service bulletin

No. 97-12

Revised 10-22-97

Gear Failures - 40/50 and 45/50

Gear Housing Assembly

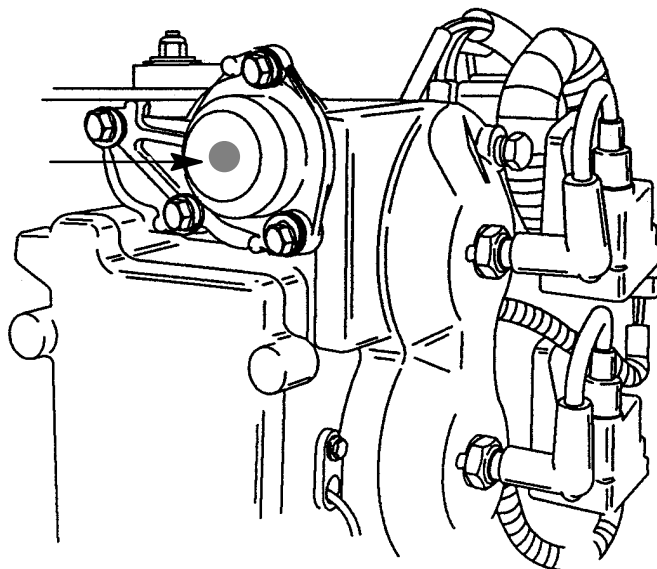
The outboards listed require replacement of the original 1.83:1 ratio gear housing assembly due to an incorrect pinion gear/forward gear engagement. The pinion gear has been revised to prevent forward gear tooth chipping and possible gear housing assembly failure. The new pinion gear p/n 43-822161--2 has been installed into the gear housings after the serial numbers listed.

Replace the complete gear housing assembly on outboards listed that do not have the factory rework orange dot.

1682-821306A24	Black	Long	45/50
1682-821306A25	Gray	Long	45/50
1682-821306A26	Black	Short	40/50
1682-821306A27	Gray	Short	40/50
1682-821306A28	Black	Long	40/50
1682-821306A29	Gray	Long	40/50

REPAIR IDENTIFICATION

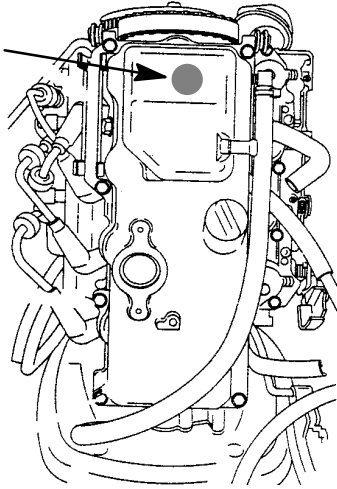
- 40/50 (3 Cylinder 2-Stroke) - an orange dot on the thermostat cover.

- 45/50 (4 Stroke) - an orange dot on the upper half of the valve cover.

- Mark a white dot on the:
 - ◇ 40/50 (3 cylinder – 2-Stroke)- thermostat cover.
 - ◇ 45/50 (4 cylinder - 4 Stroke) - upper half of the valve cover.
